**From:** Rachael Oldroyd  
**Sent:** 16 May 2019 13:13  
**To:** Planning  
**Subject:** RE: NYMNPA NYM/2018/0611/FL (Boggle Hole Youth Hostel, Mill Bank, Mill Beck, Fylingthorpe)

YHA (ENGLAND & WALES) LTD	client
YHA BOGGLE HOLE, MILL BECK FLYINGTHORPE, NORTH YORKSHIRE	project
<b>PROPOSED ELEVATION</b>	title
YHA46	job No.
AV1.02 - Rev B	dwg No.
1:100 @ A3	scale
AM	drawn

YHA (ENGLAND & WALES) LTD	client
YHA BOGGLE HOLE, MILL BECK FYLLINGTHORPE, WHITBY	project
PROPOSED MAIN REFUSE STORE FENCE & SETTING OUT	title
YHA46	job No.
CW-AD1.04/F	dwg No.
1:20@A3	scale
RCO	drawn

West Elevation

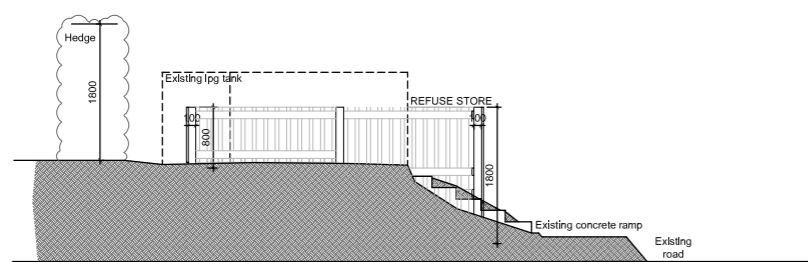
The falls to the slab and ramp width have been added to the west and north elevations respectively.

South Elevation

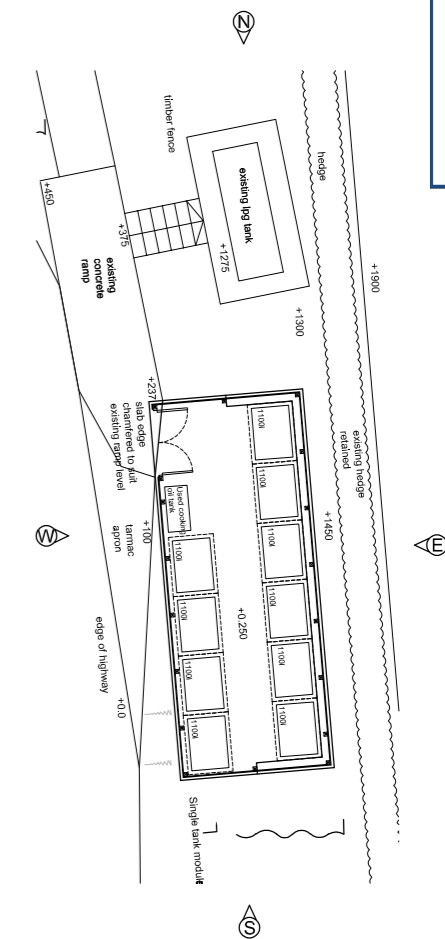
The notation to the soakaway had been corrected and the position of the gully connecting the soakaway has been added. The group of modules is sized as per the manufacturer's recommendations to suit the size of the new slab. The position of the soakaway below ground has also been included on the south elevation drawing.

REFUSE STORE PLAN  
Scale 1:100

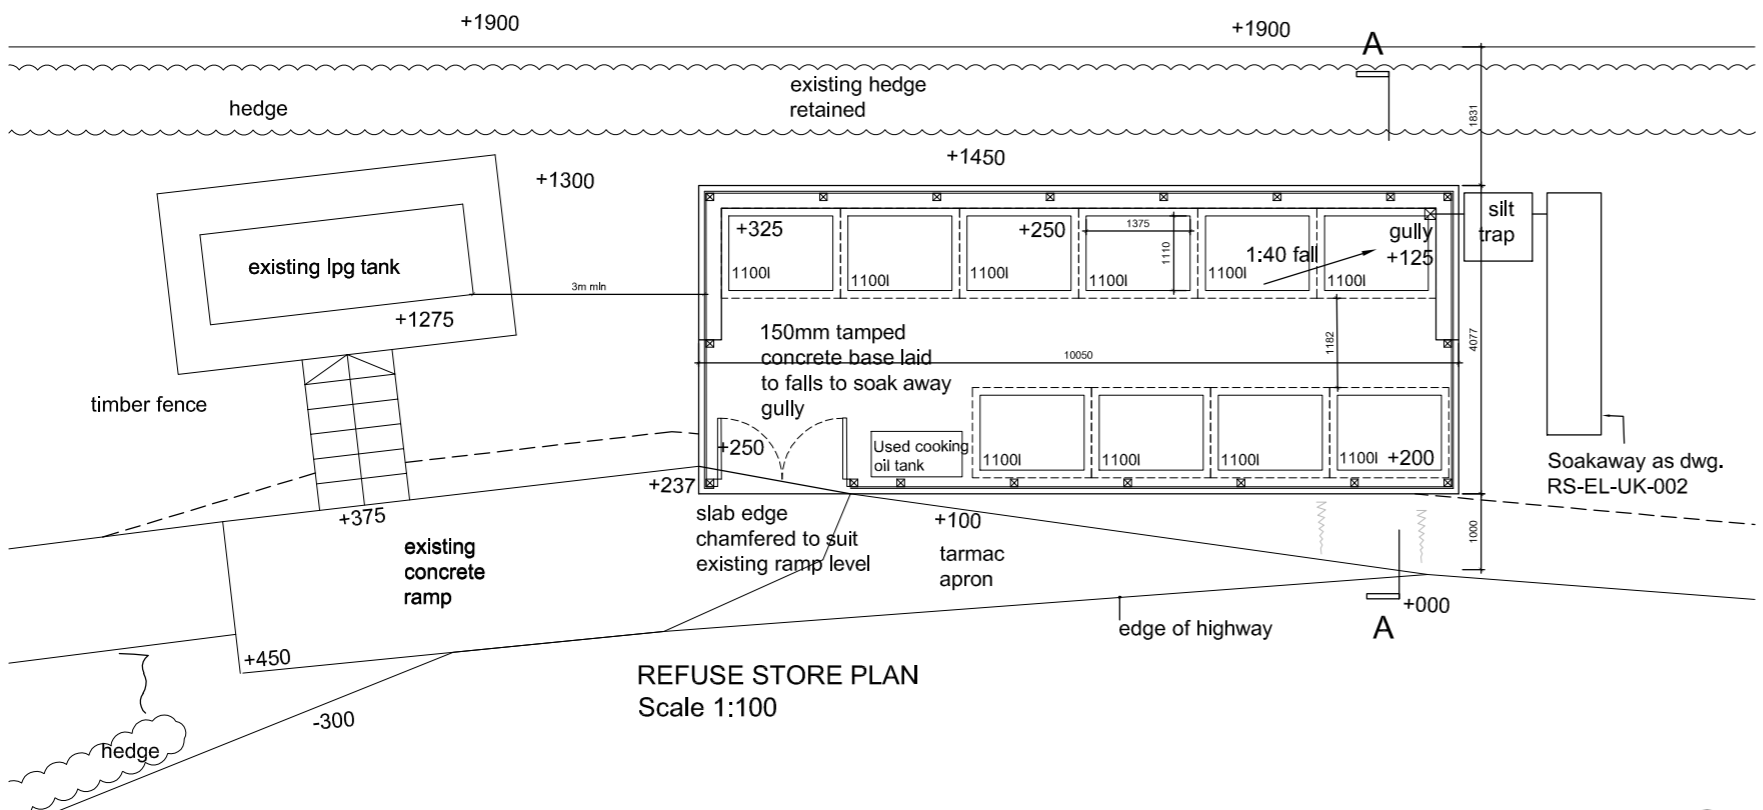
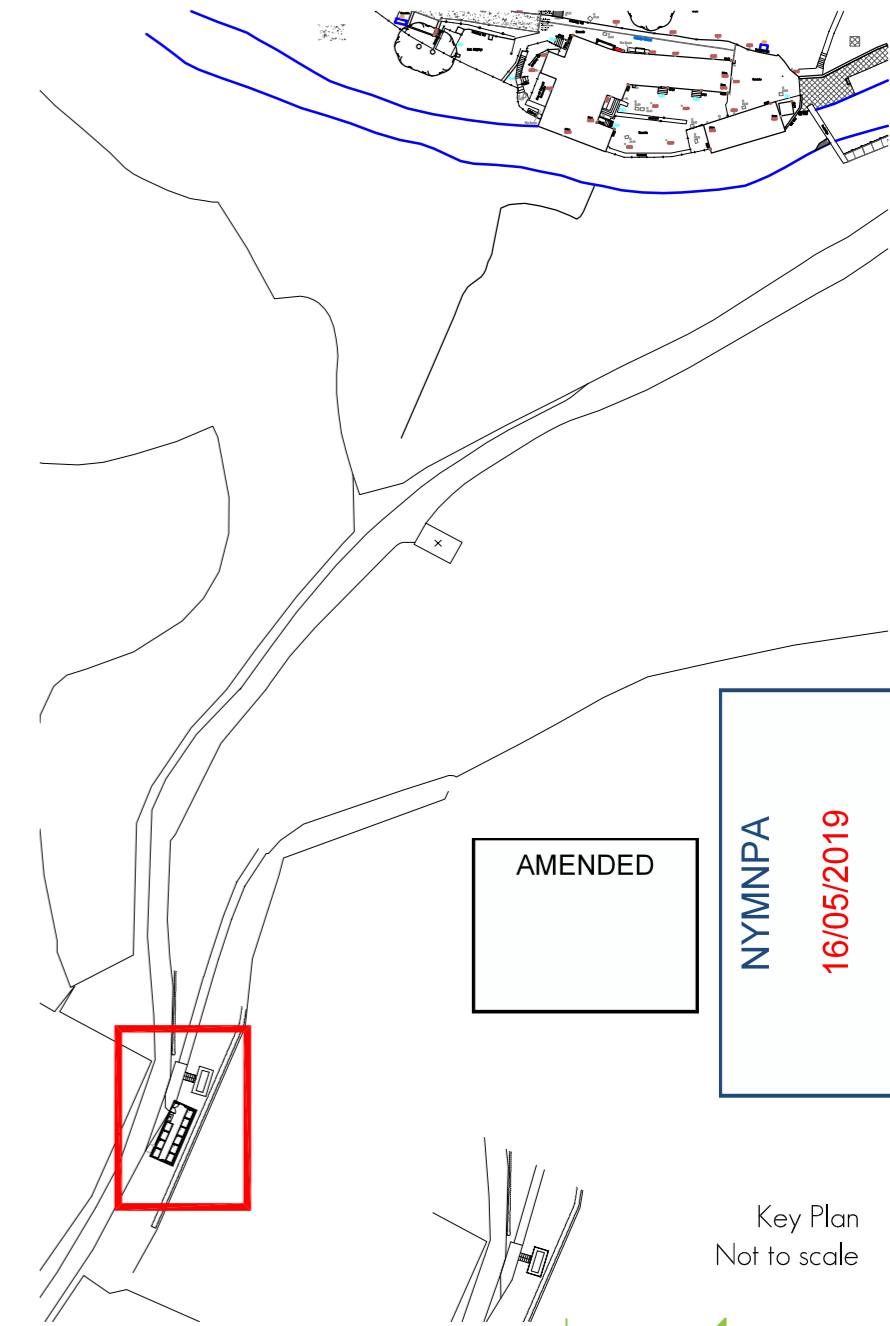
The height measurement on the slab was incorrectly shown in meters instead of mm and this has been corrected. All heights are in relation to the datum point of '0' shown in the roadway and are in relation to the top of the slab.
